PROJECT TITLE: Yale heservoir zon	NE ATLAS/DRNG. FILE #: K-14028
CITY ADDRESS: not available 2201	Chingo S
	antral NE
ENGINEERING FIRM: Tom Mann & Asse Inc	CONTACT: Tom Mann
	PHONE: 265-5611
OHNER: City of Albuqueique	CONTACT: Art Stewart.
ADDRESS: Po. Box 1293	PHONE: 168 2772
HRCHITECT: CH2M H11	CONTACT: Pete Jacobson
ADDRESS: 6121 Indian School WE	PHONE: 884-5600
JRVEYOR: Jom Mann & Assoc Inc	CONTACT:
ADDRESS:	PHONE:
CONTRACTOR:	CONTACT:
ADDRESS:	PHONE:

RE: CONCEPTUAL GRADING & DRAINAGE PLAN FOR YALE

RESERVOIR (K-16/D28) ENGINEER'S STAMP DATED APRIL 24, 1987

CONCEPTUAL GRADING AND DRAINAGE PLAN

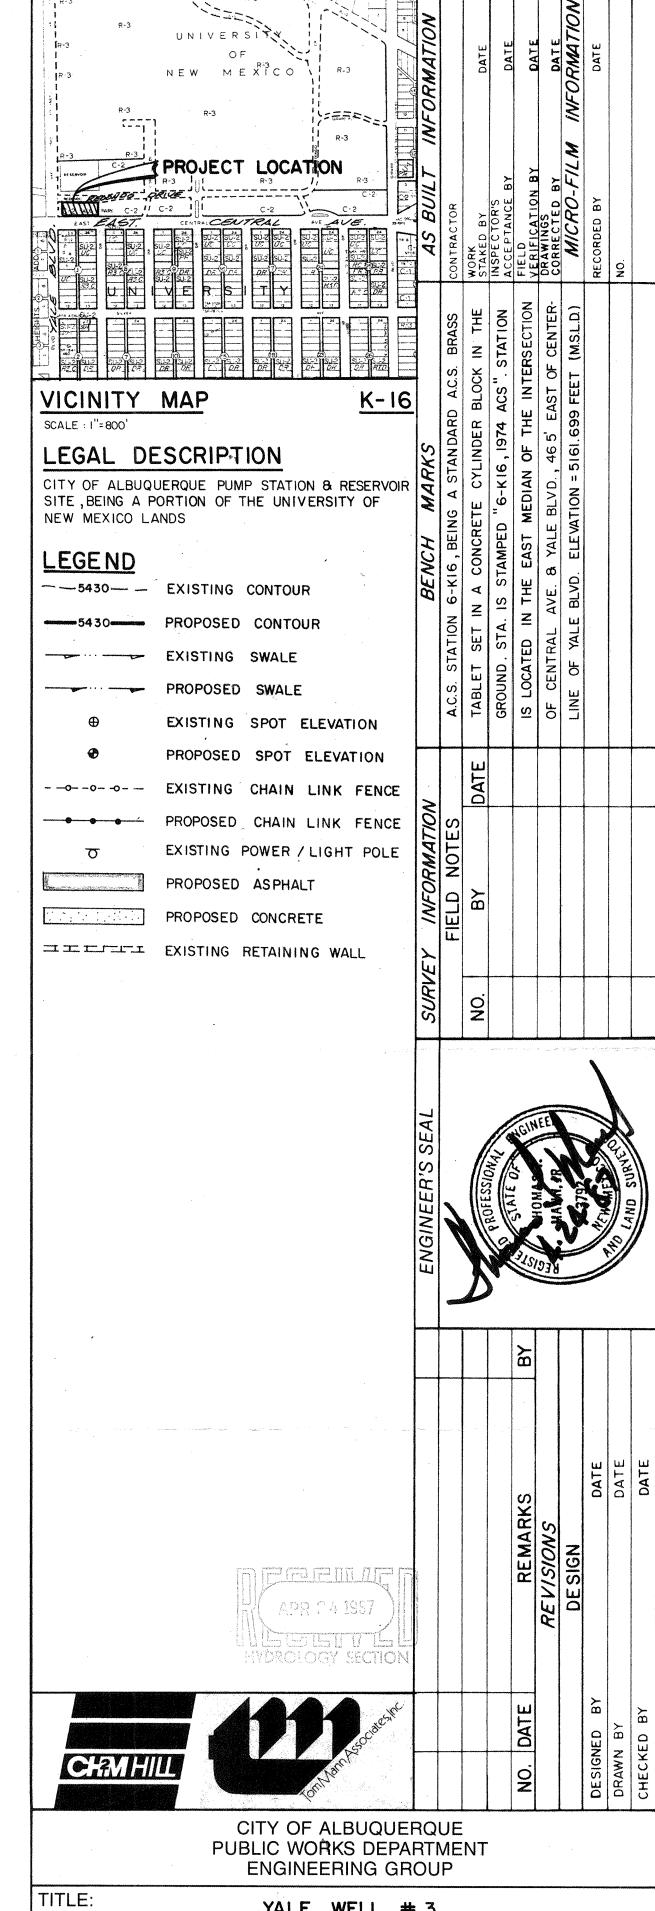
Based on the information provided on your submittal of April 24, 1987, the above referenced conceptual drainage plan is approved for Site Development.

Please be advised that prior to Building Permit release, a submittal indicating Building Permit approval will be required.
